SERVICE DIRECTIVE BULLETIN

Service Directive Bulletin No. 0061

SUBJECT: Clutch Engagement Overcenter Lock Warning Light Installation

MODELS: F-28A, 280, F-28C, 280C, F-28F and 280F Helicopters

FIGURE 1

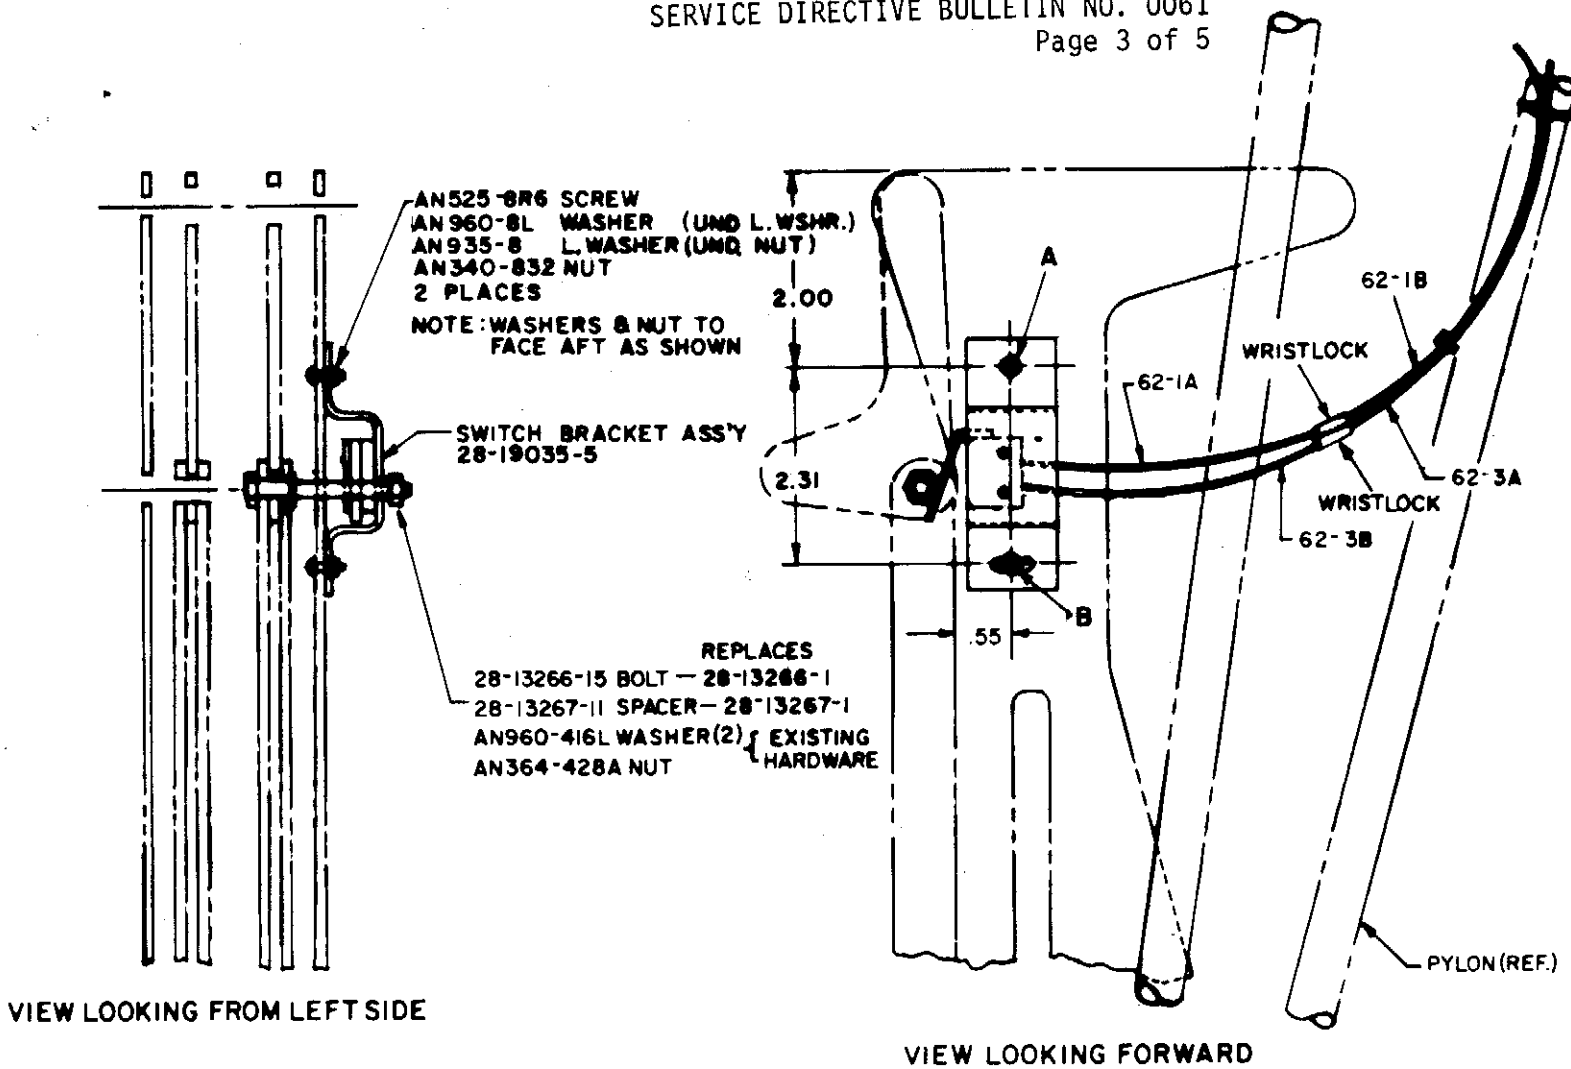
Installation can be made as follows, reference Figure 1. Change pivot hardware as noted on the aft side of assembly by removing the 28-13266-1 bolt and 28-13267-1 spacer and replacing them with a 28-13266-15 bolt and the 28-13267-11 spacer. Locate and drill two .171" diameter holes for mounting the switch bracket on the aft plate of overcenter mechanism. Install switch bracket assembly 28-19035-5 with two AN 525-8R6 screws and associated hardware as noted to the aft plate, reference Figure 1.

Reference Figure 1, connect wire number 62-1B to existing wire wrist lock on switch wire number 62-1A. Connect wire number 62-3A to existing wire wrist lock on wire number 62-3B. Slide plastic tubing over wire and wrist lock connectors. Secure with cable ties. Wiring should be checked for security with cable ties as required.

FIGURE 2

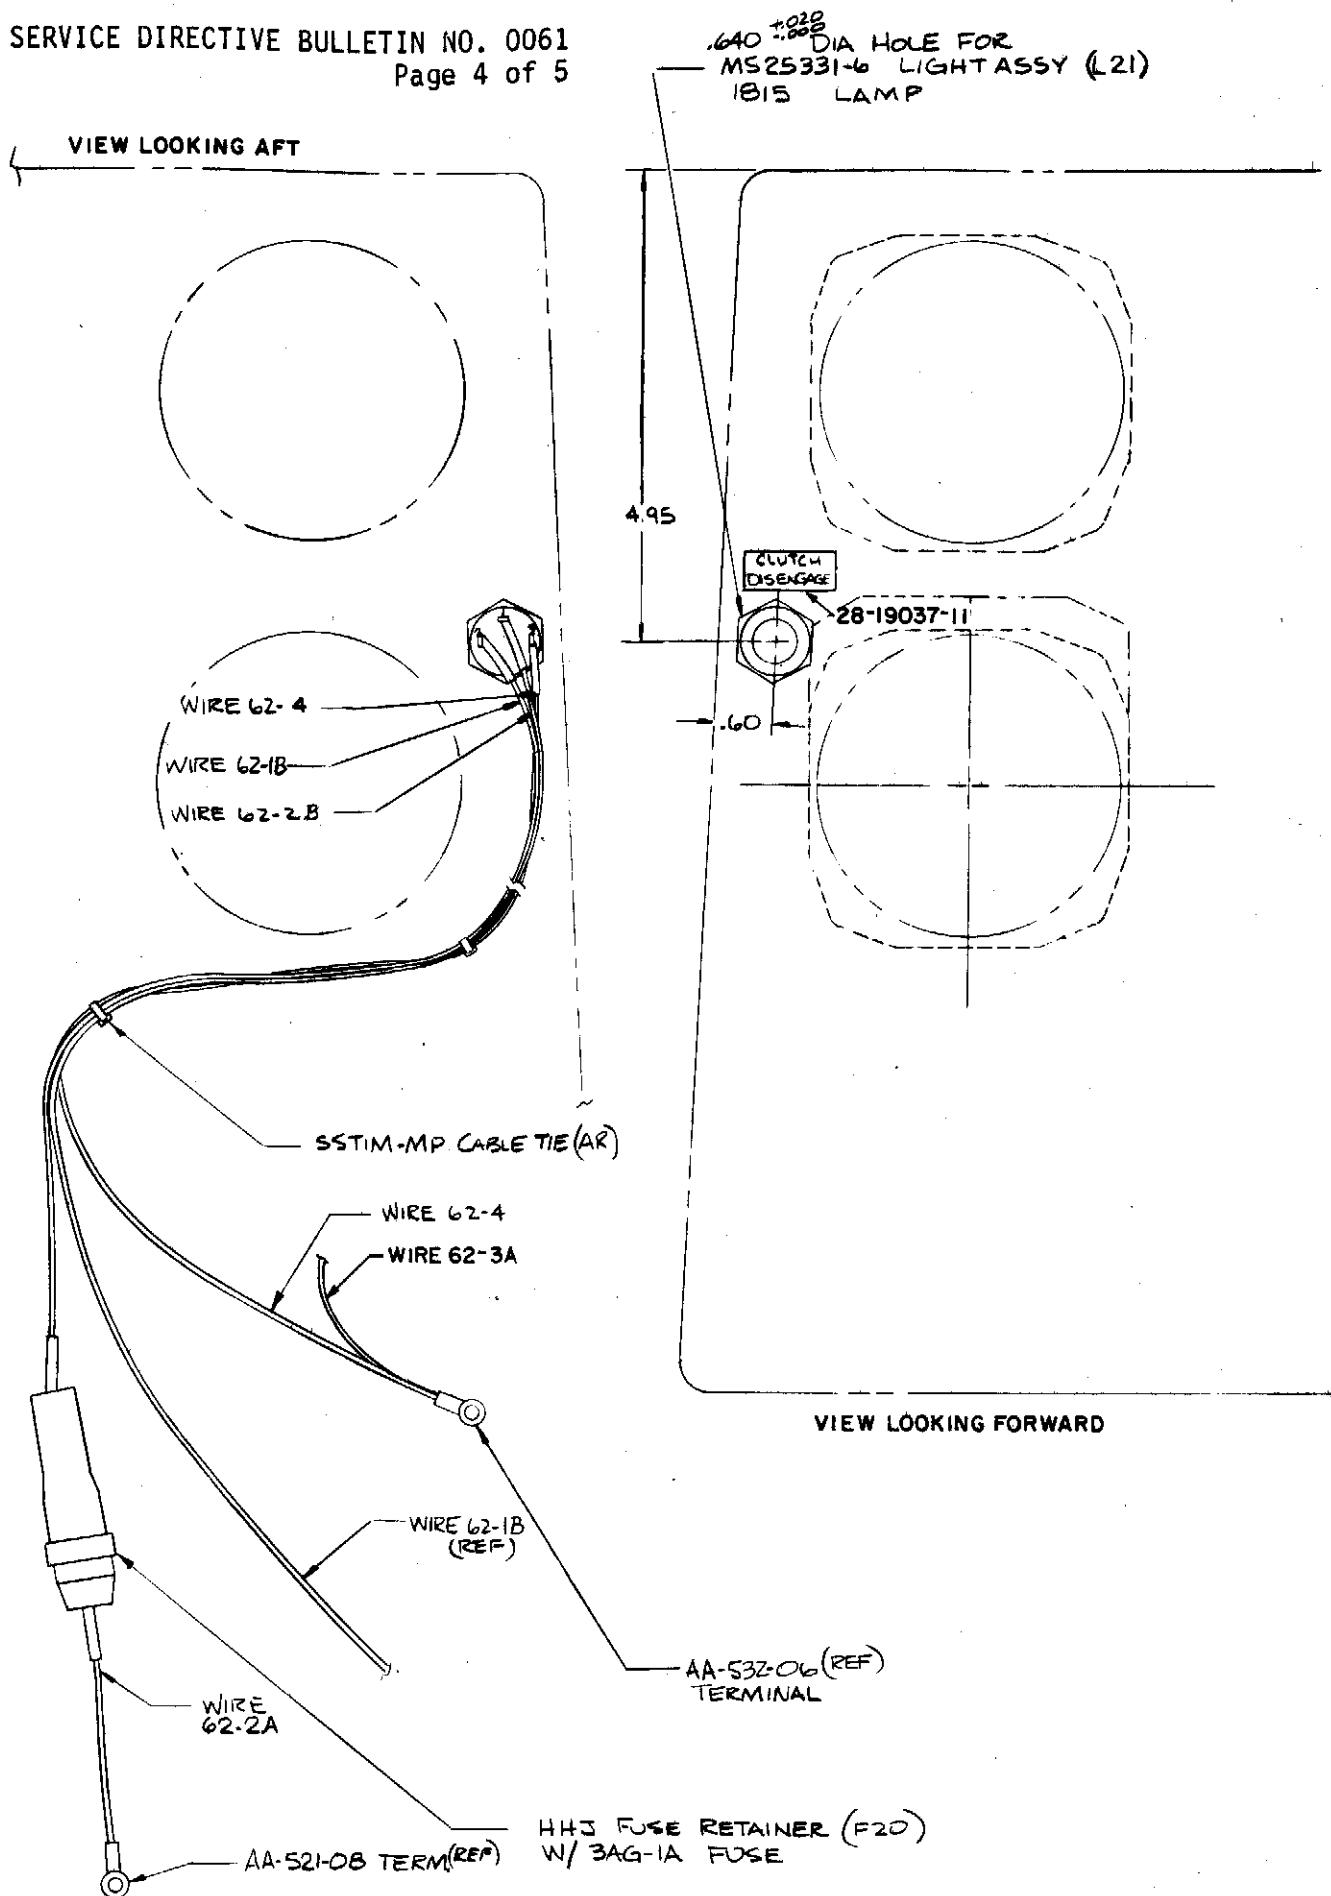
Reference Figure 2, remove instrument console shroud. Locate and punch a .640 diameter hole for warning light mounting in panel.

Install warning light (MS25331-6) into panel, install panel wiring per Figure 2, and attach placard 28-19037-11 as indicated. Attach terminal on wire number 62-2A to existing Buss at CB12 terminal #1 hot side. Attach terminal on ground wires 62-4 and 62-3A to terminal #12 on (T2) existing ground terminal at panel. Route wires number 62-1B and 62-3A through bottom cabin bay and pylon area as noted in Figure 3, and secure with cable ties as indicated.
